RE: Information Request No. 4 to TGS/PGS/MKI  
File OF-EP-GeoOp-M711-555-4587 02  
CEAR File # 10-01-53884

As per your letter of March 19<sup>th</sup>, 2013, please find MKI responses to Information Request Number 4.

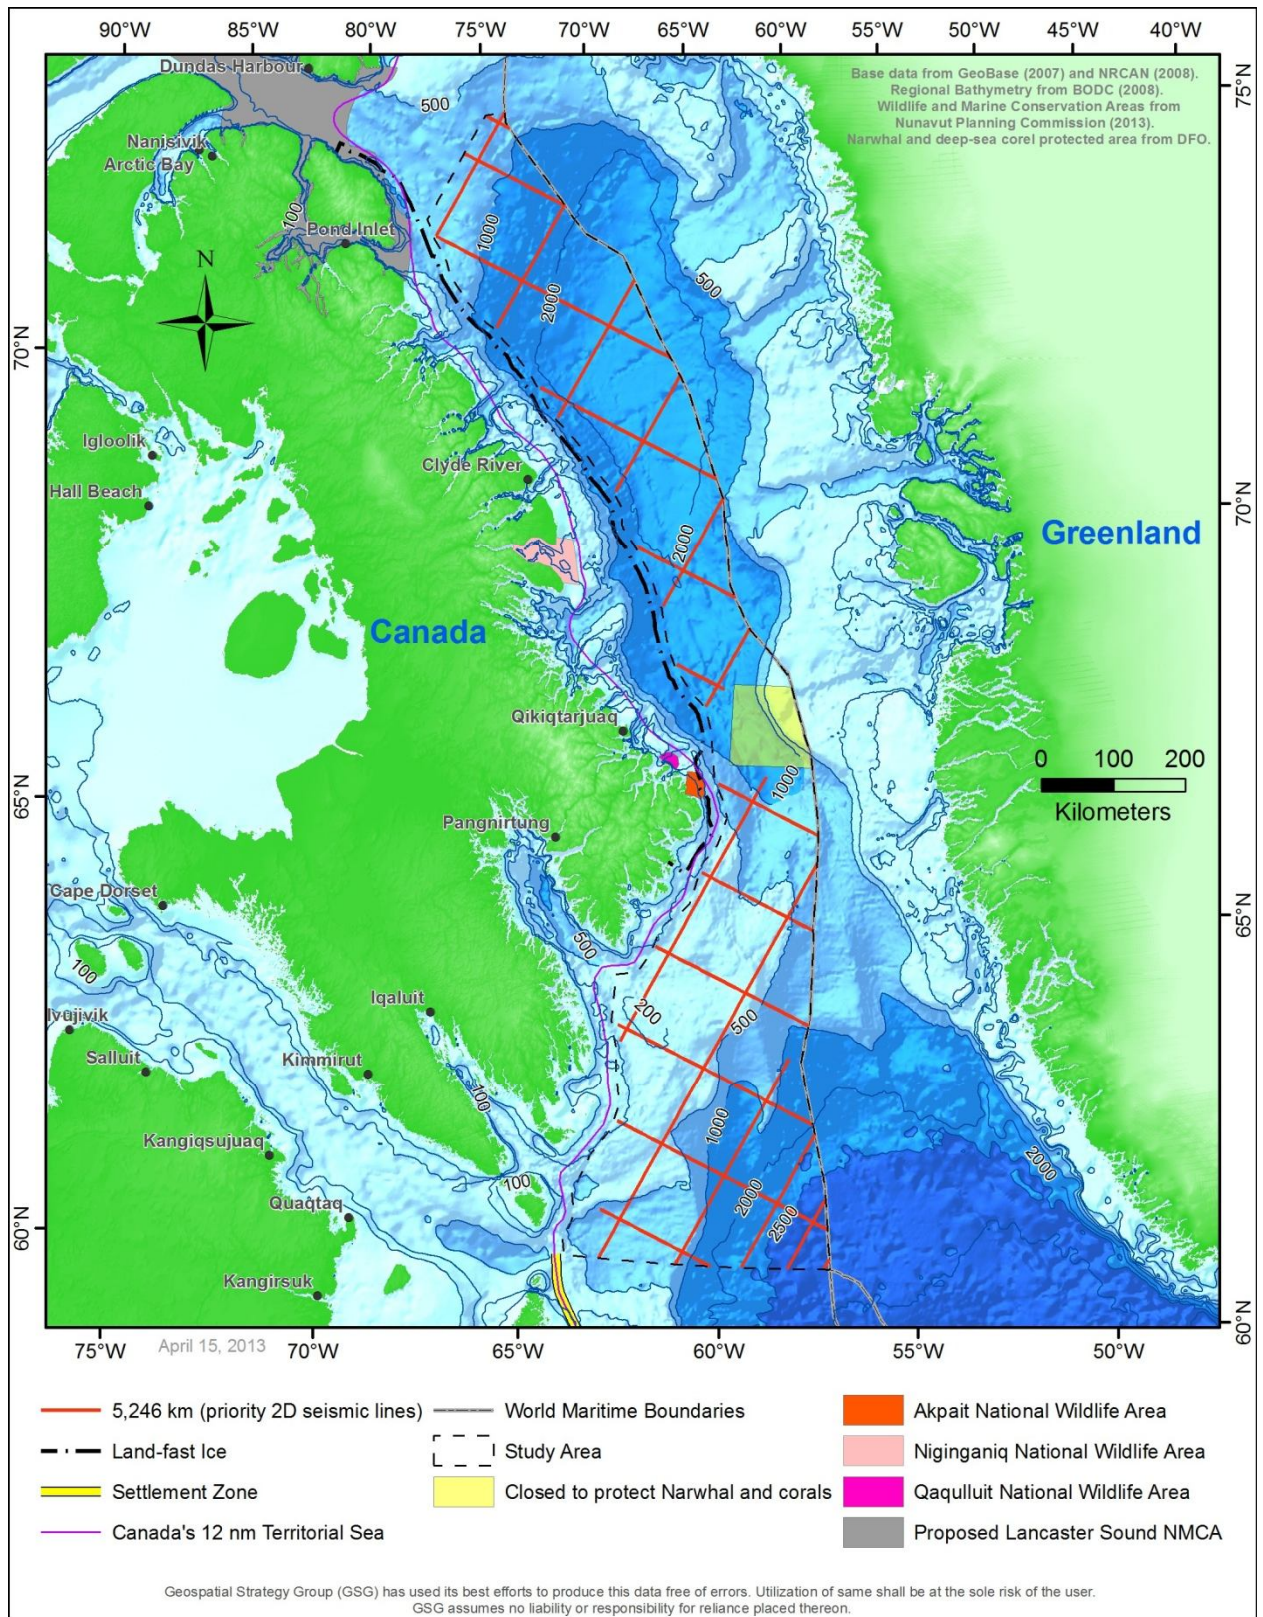
Please indicate when the Survey Acquisition Plan will be submitted to the NEB. Alternatively, confirm that MKI plans to acquire lines indicated in their Environmental Impact Assessment (page 14, Figure 1).

MKI Response: MKI seeks approval of the full 16,173 km shown in Figure 1 of the EA page 14. These lines are to be collected over a number of years. MKI is currently working on the acquisition plan for the project and priority lines for year one. Shown below in Figure 1 are the expected Priority Lines for 2013 acquisition. This represents 5,246 km of the proposed 16,173km outlined for approval. The lines to be acquired in the first year will depend on the requirements of pre committing companies and this is difficult to finalize at this time. For this reason MKI seeks the full approval of all lines and also as noted above in order to allow flexibility in

collection of lines as necessary to mitigate fisheries concerns. The full acquisition plan will be provided to the NEB 30 days before commencement of the survey acquisition, no later than July 15, 2013.
